Amendment to the Application to the
North Dakota Public Service Commission
for
Consolidated Certificate of Corridor
Compatibility and Route Permit

Case No: PU-11-696

**AVS-Neset 345-kV
Transmission Project**

July 2014

Basin Electric Power Cooperative
Antelope Valley Station to Naset
345-kV Transmission Project
Route Change Maps
Sheet 1b of 4

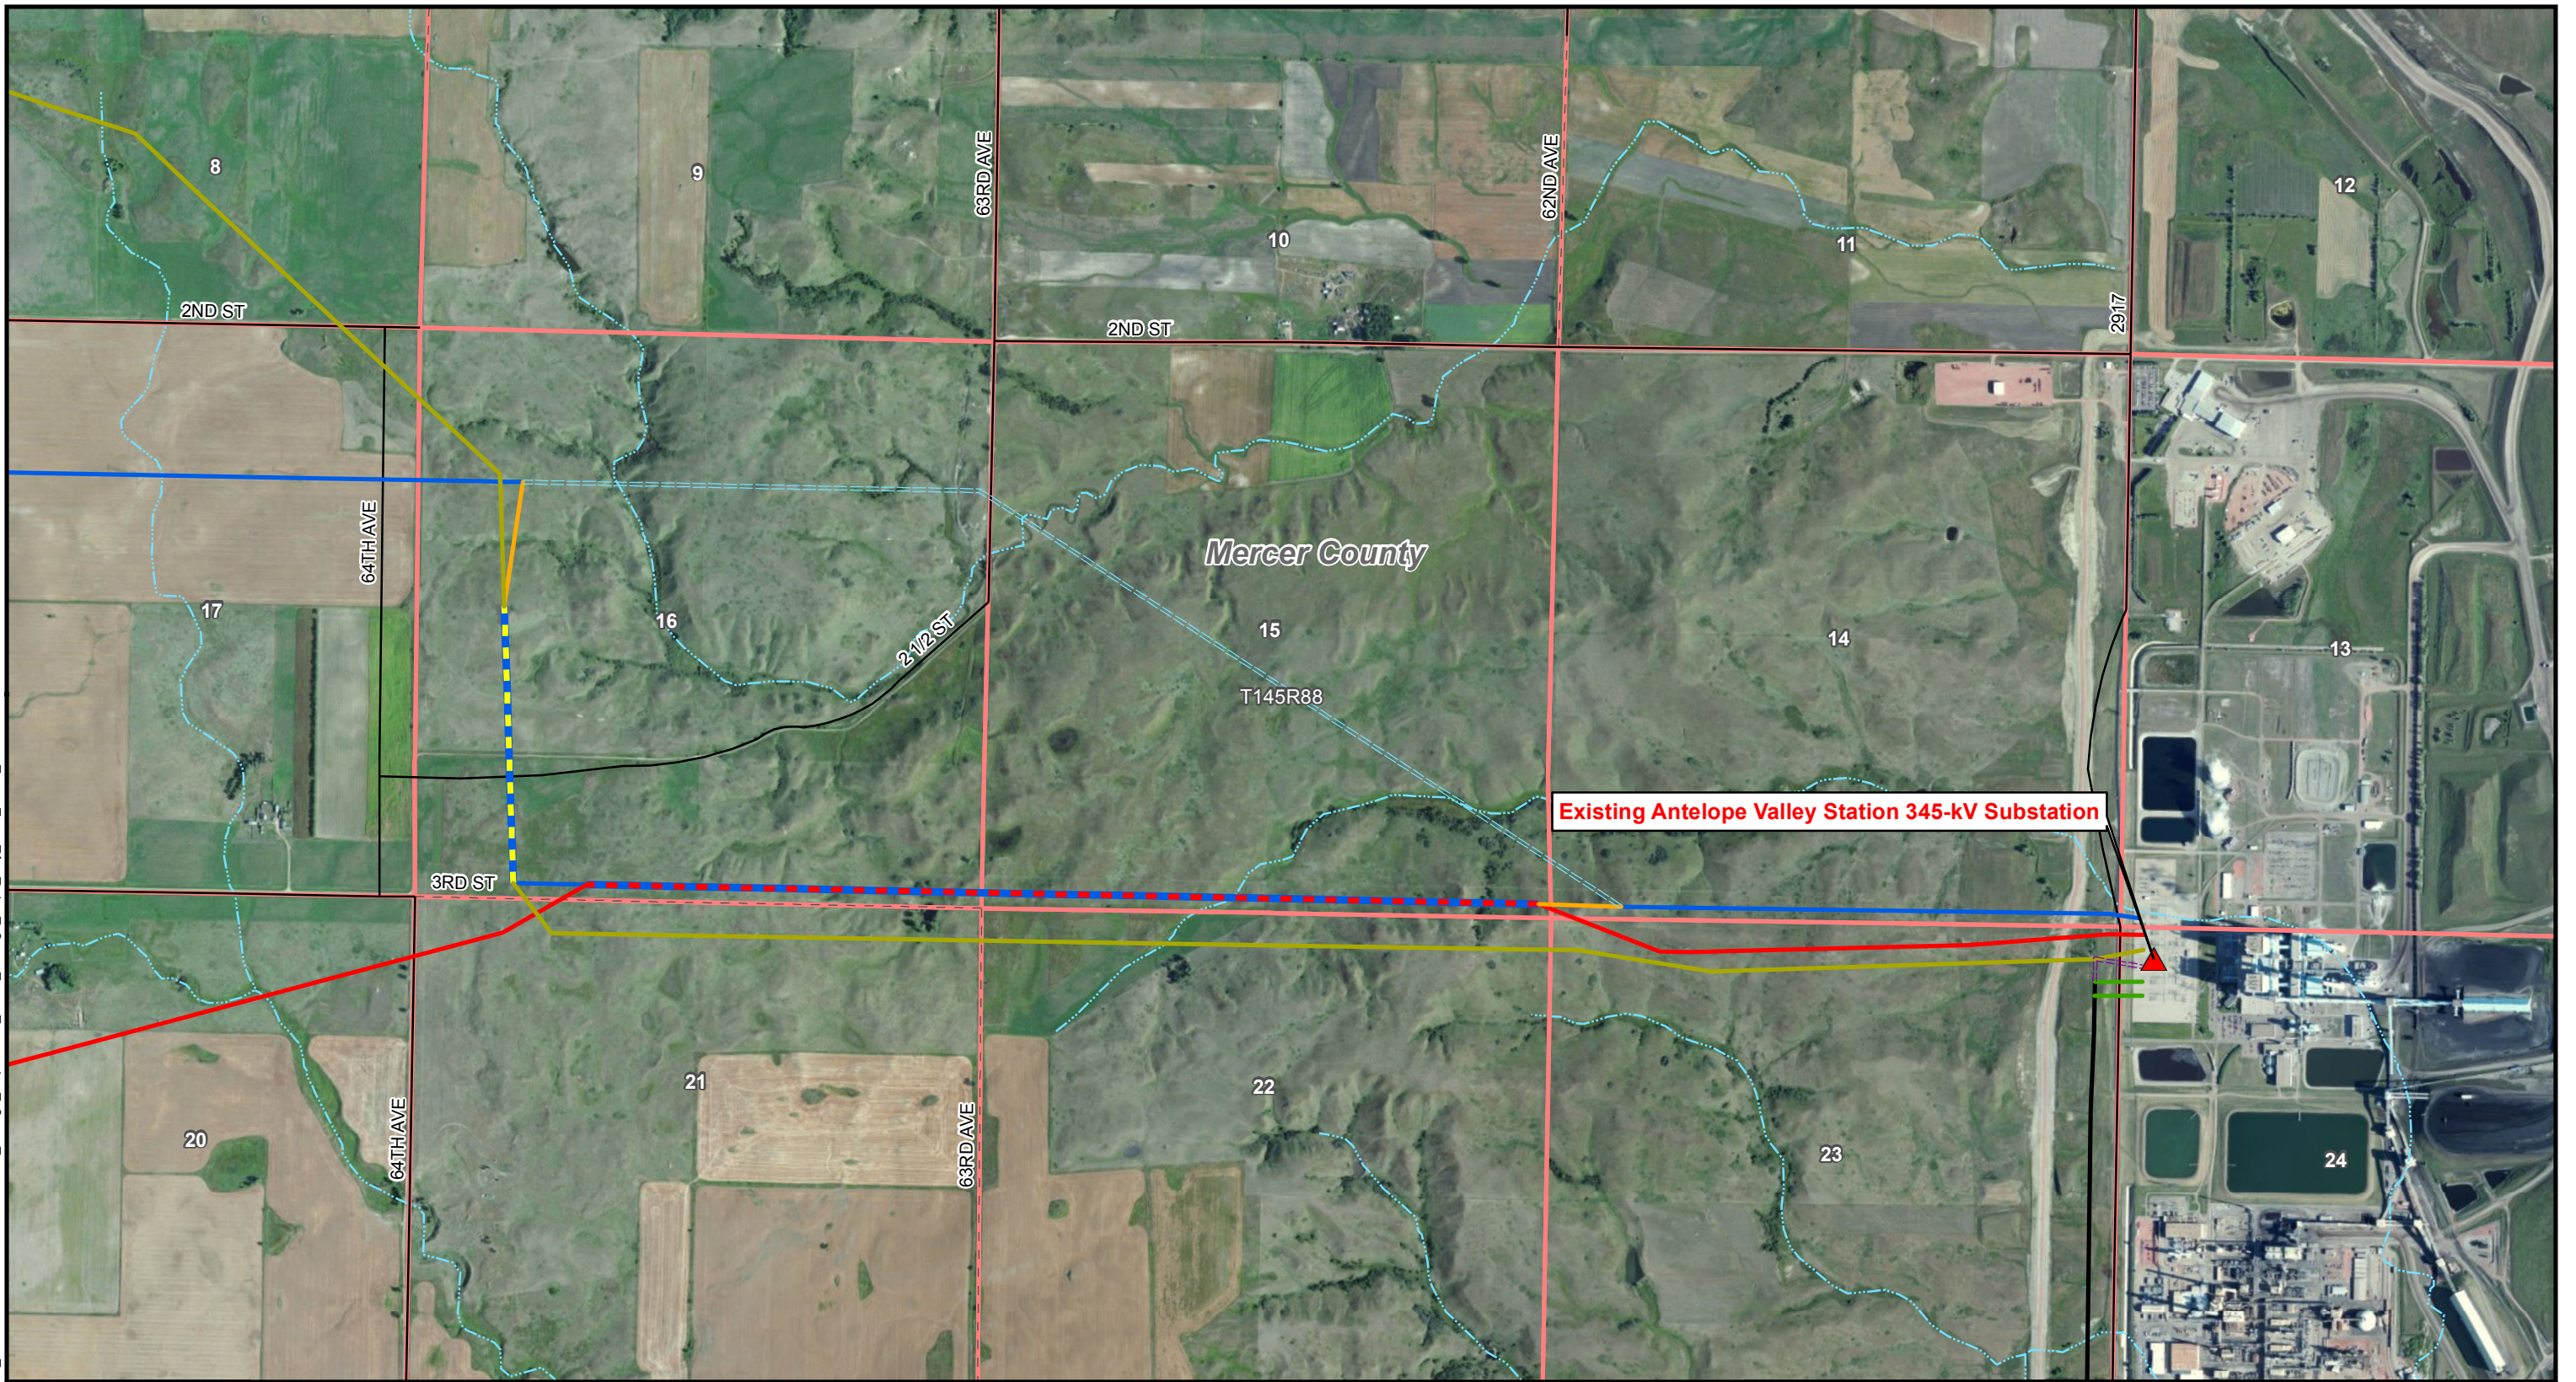
- AVS to Broadland (depicted in Red on Route Change Maps 1a and 1b),
- AVS to Leland Olds (double circuit, depicted in Black),
- AVS to Charlie Creek (depicted in Blue) transmission lines.

The proposed AVS to Neset Transmission line (depicted in Yellow) also requires interconnection to the AVS Switchyard (See Route Change Maps Sheets 1a and 1b). The existing AVS to Charlie Creek (CC) line requires relocation to facilitate mining operations. In Basin Electric's original proposal, this line was proposed to be double-circuited on the new AVS to Neset Transmission alignment for approximately 2.5 miles extending west from the AVS Substation. Upon further analysis and study of this configuration, a concern was raised that double circuiting both lines extending from AVS to CC would present reliability and National Electrical Reliability Council's compliance issues. Thus, the recommendation from Basin Electric's transmission planning department was to avoid or minimize the amount of double circuiting of the existing and proposed AVS to CC circuits, placing as much of these circuits on different structures as practicable. By incorporating separate structures for each line, transmission delivery between the same geographical areas would not be subject to a single event failure.

Basin Electric Power Cooperative
Antelope Valley Station to Naset
345-kV Transmission Project
Route Change Maps
Sheet 2 of 4

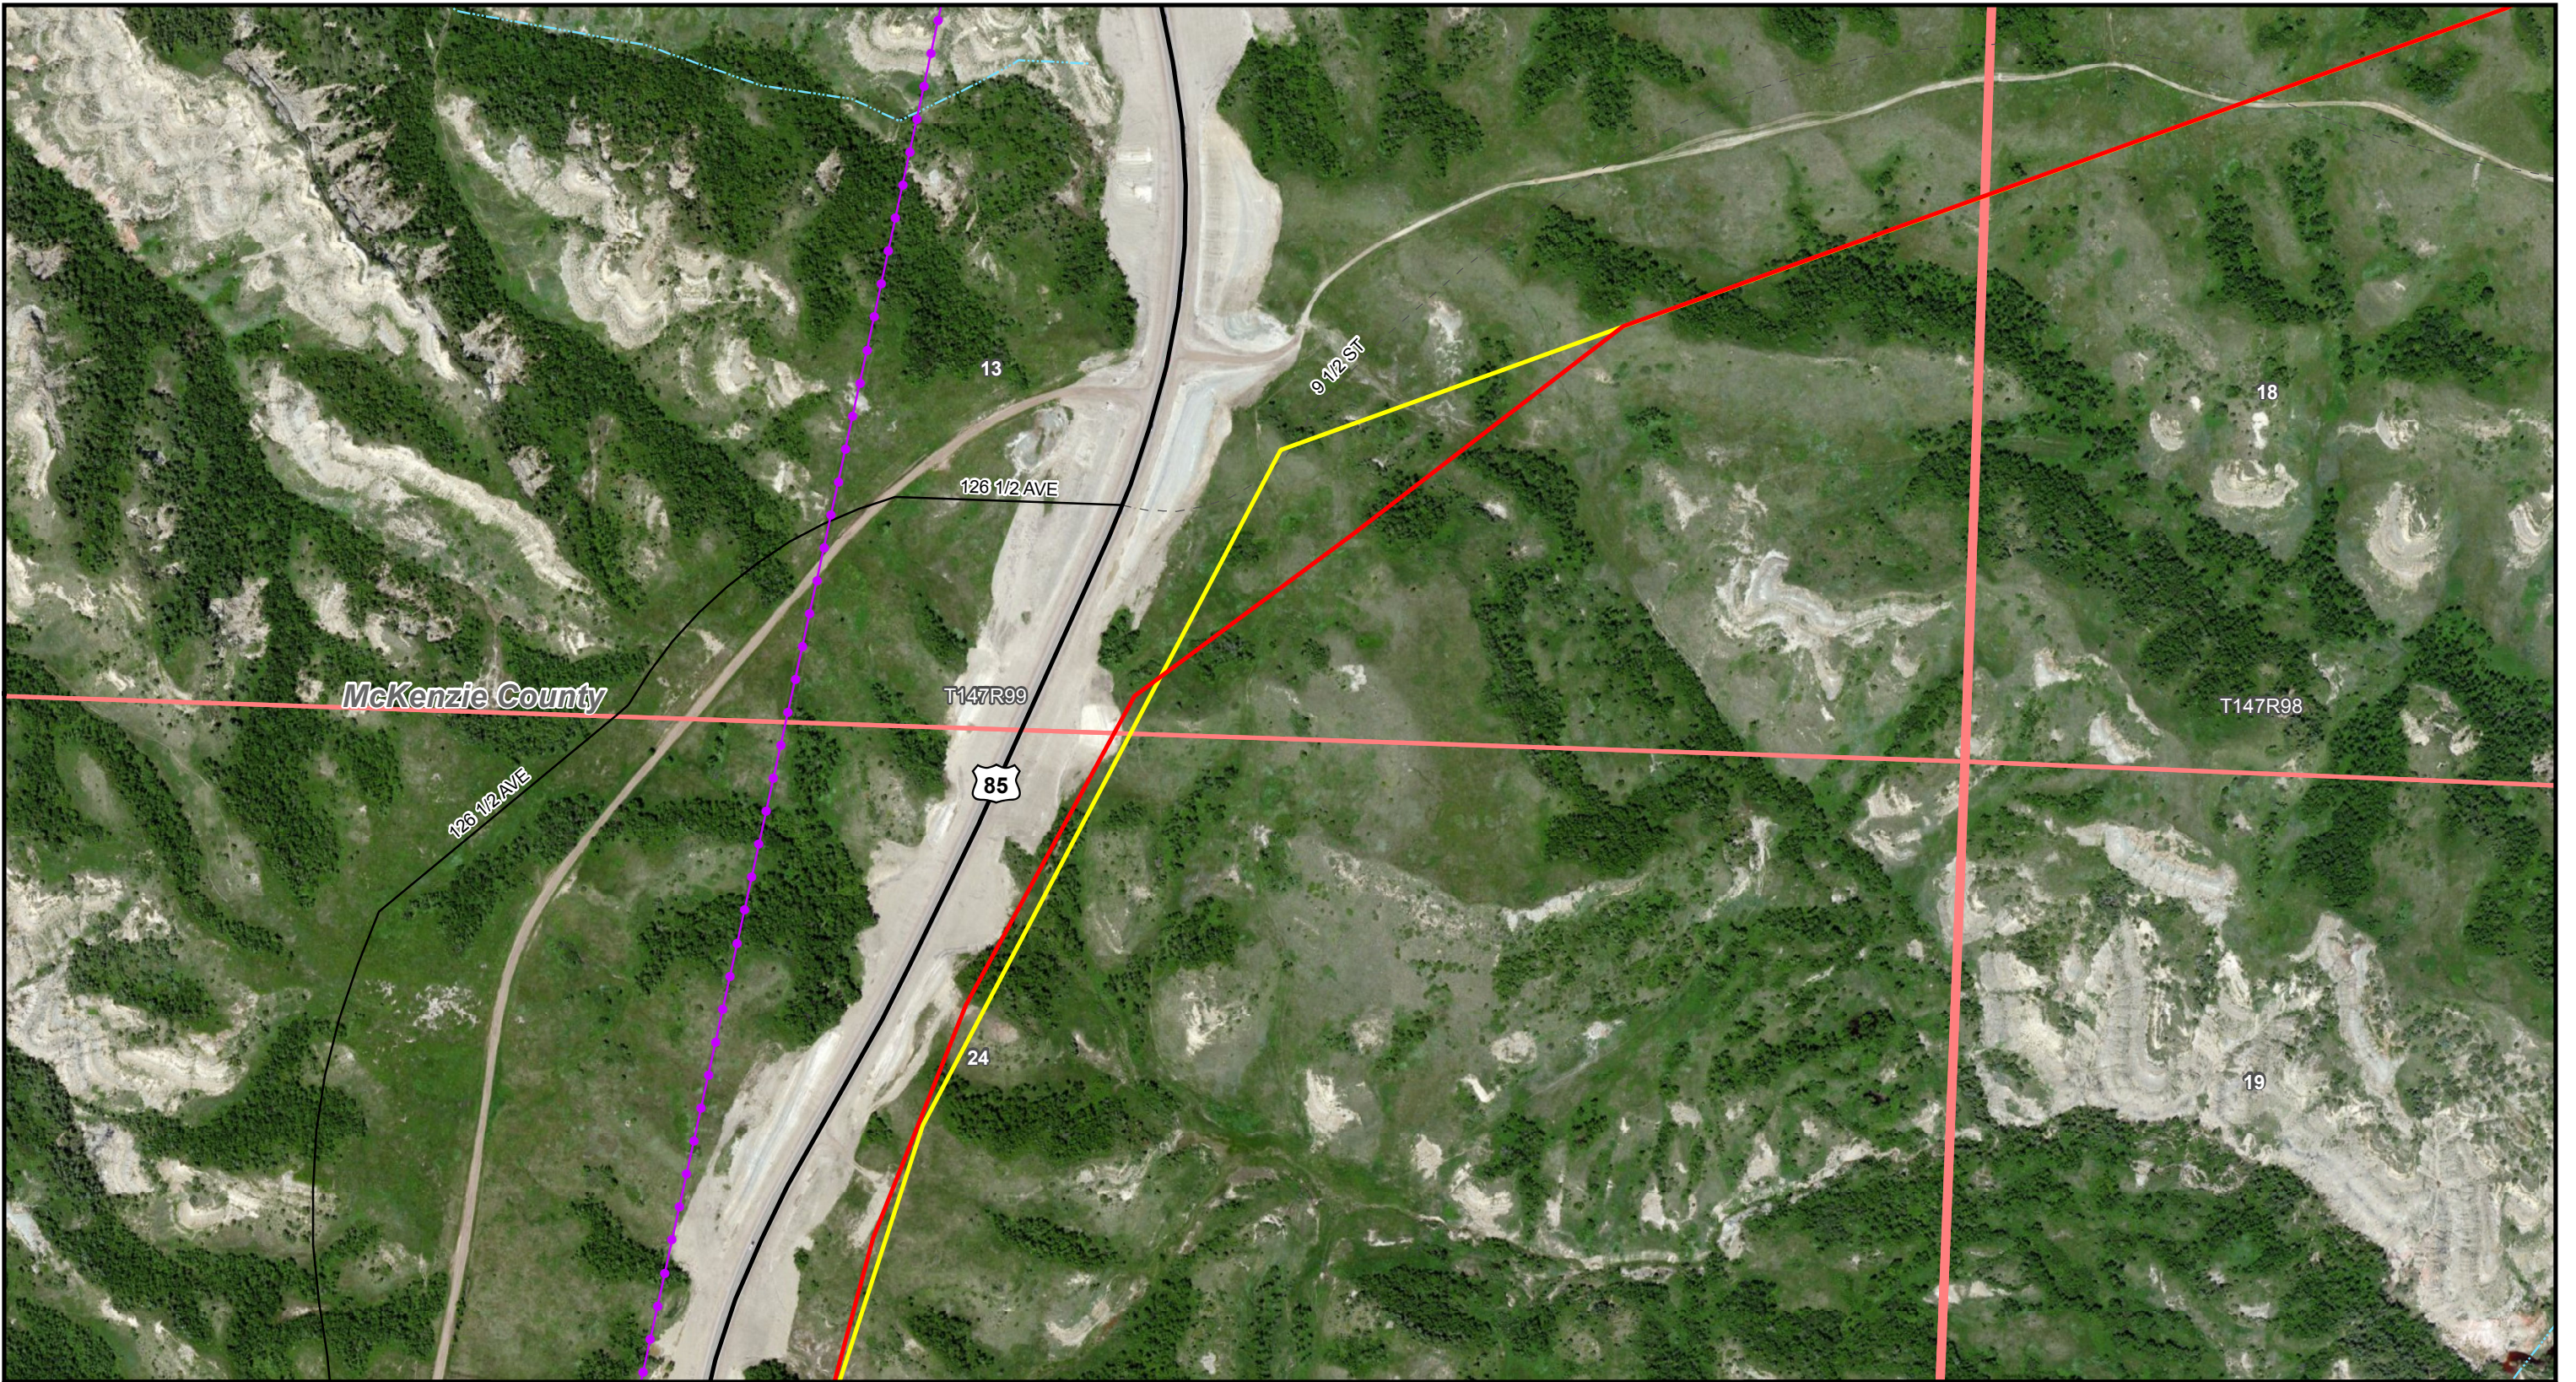
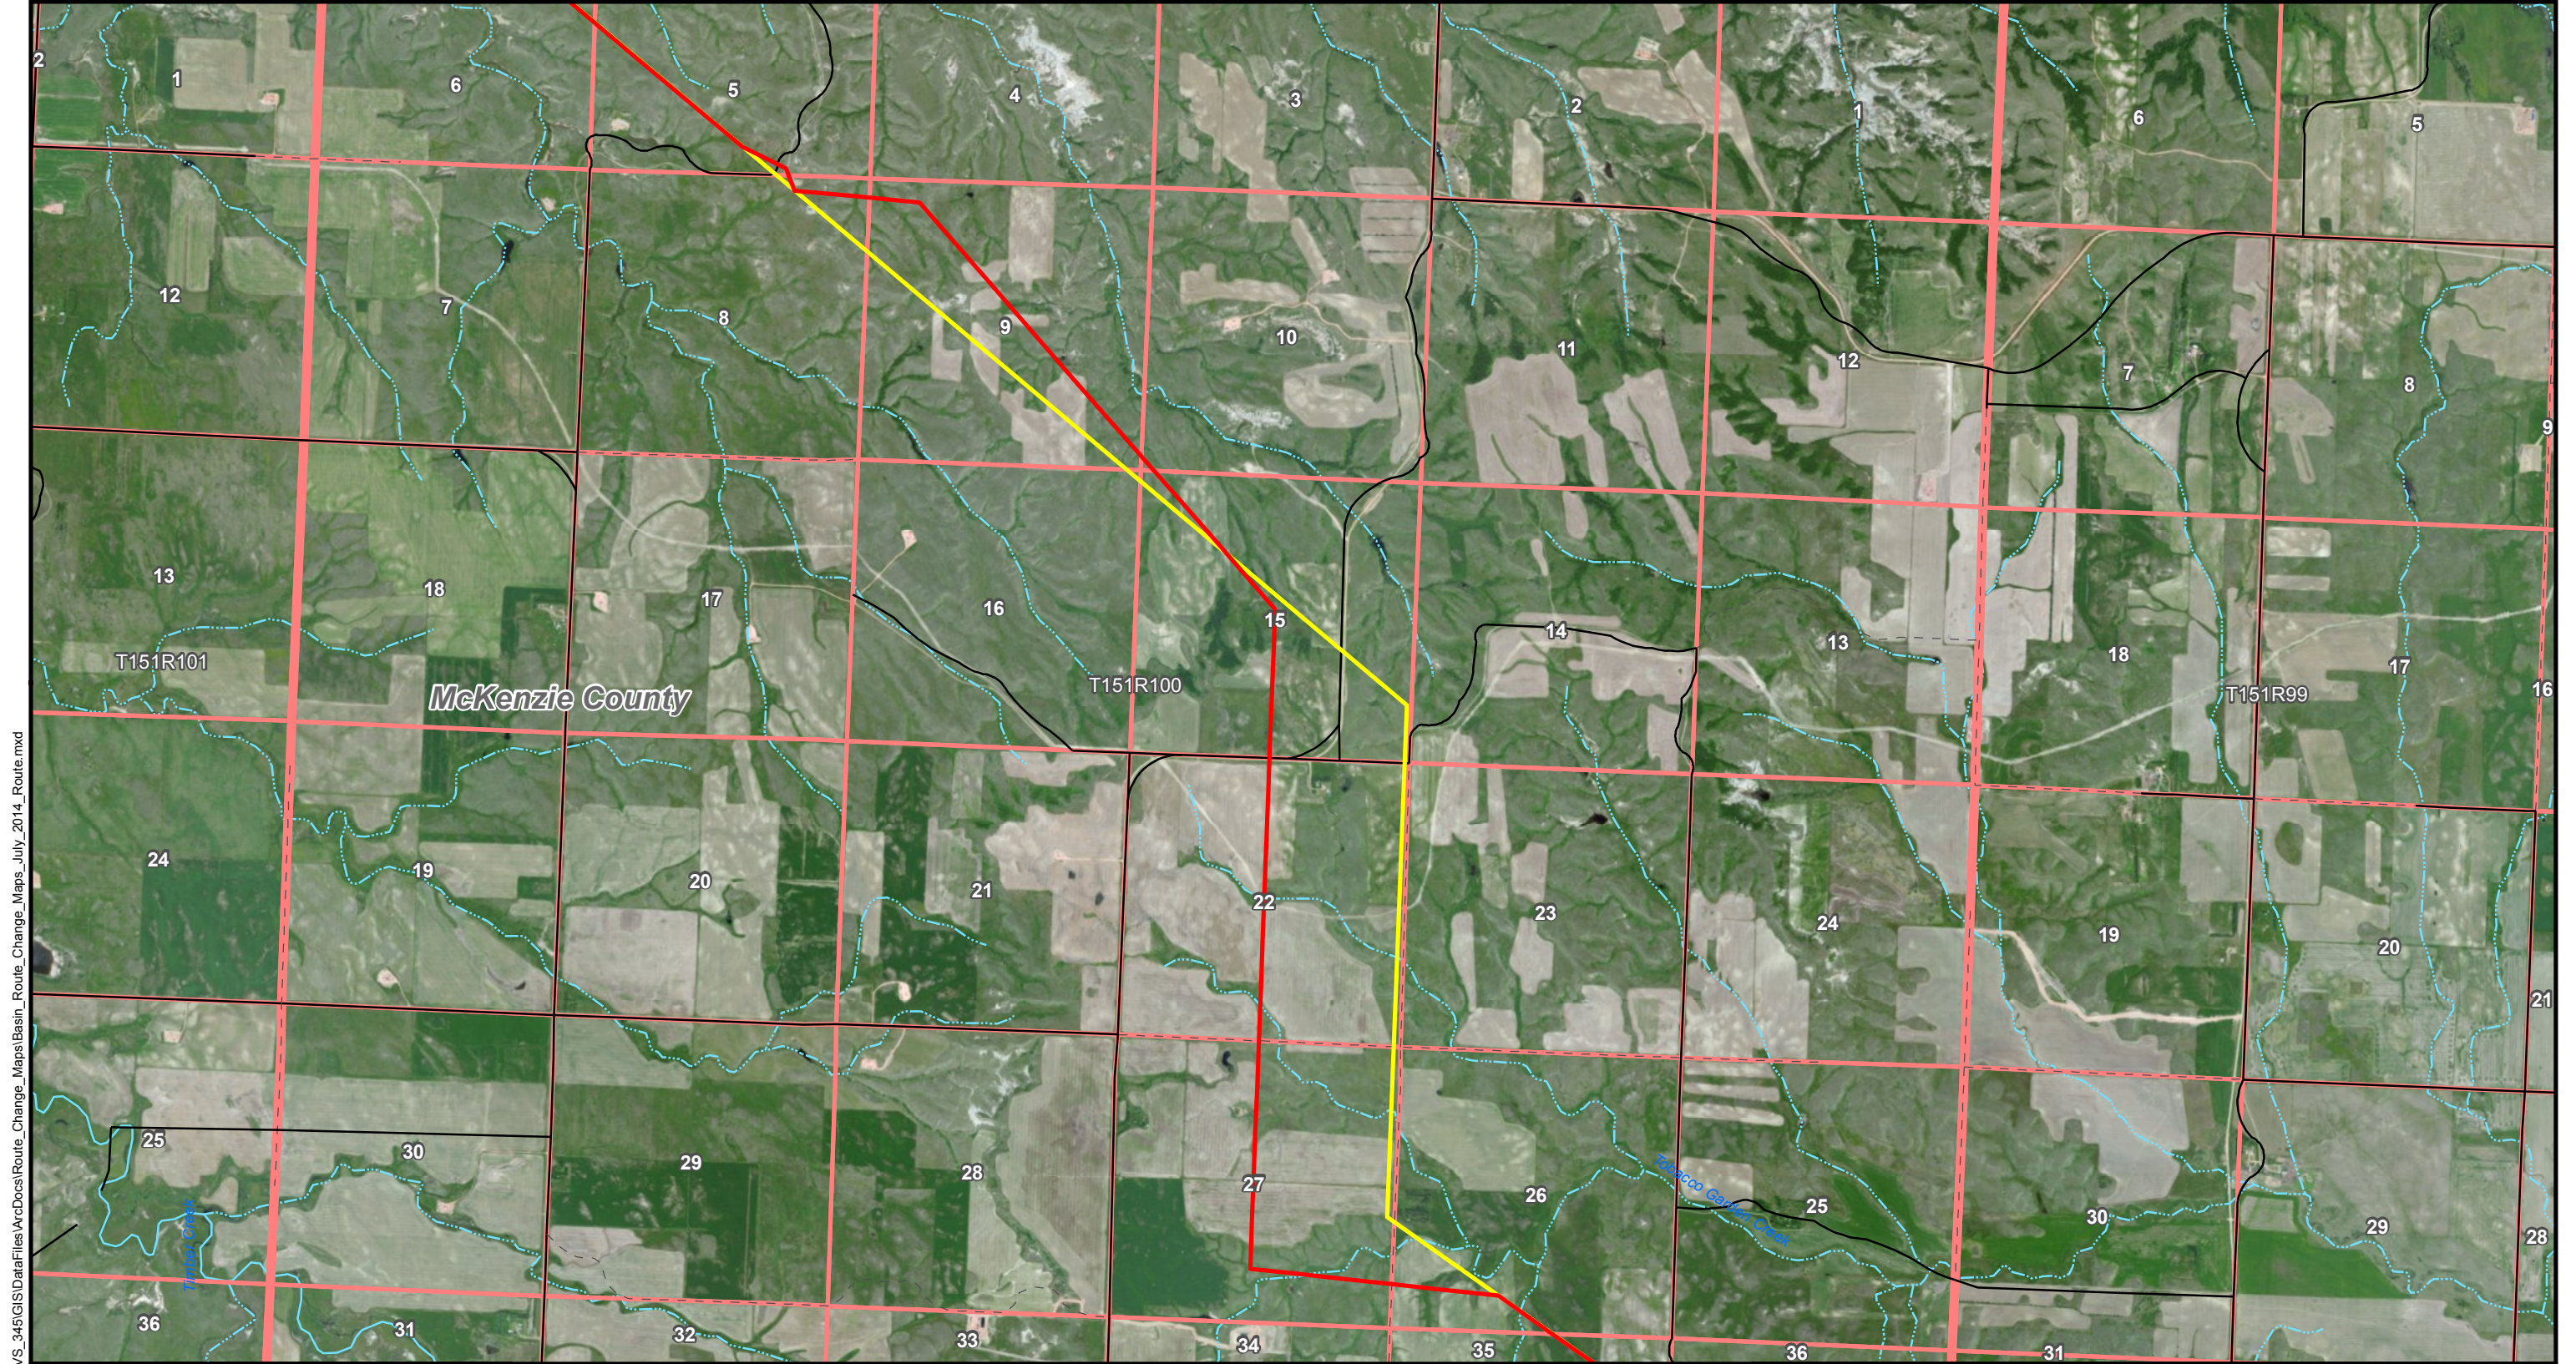
Route Change Map Sheet 2 indicates, in preparation for future mining operations in 2015, a two-mile segment of the existing AVS to CC line (Sections 15 and 16, Township 145N, Range 88W) would be relocated (depicted Ghost Blue) to parallel the north side of the existing AVS to Broadland alignment. This more northern alignment would be constructed as a 345/345-kV double circuit line. Approximately two miles of the existing AVS to Broadland circuit would be moved from its current structures to be co-located with the existing AVS to CC line for approximately two miles west from the switchyard. Switchyard bay connections would be unchanged for these two circuits.
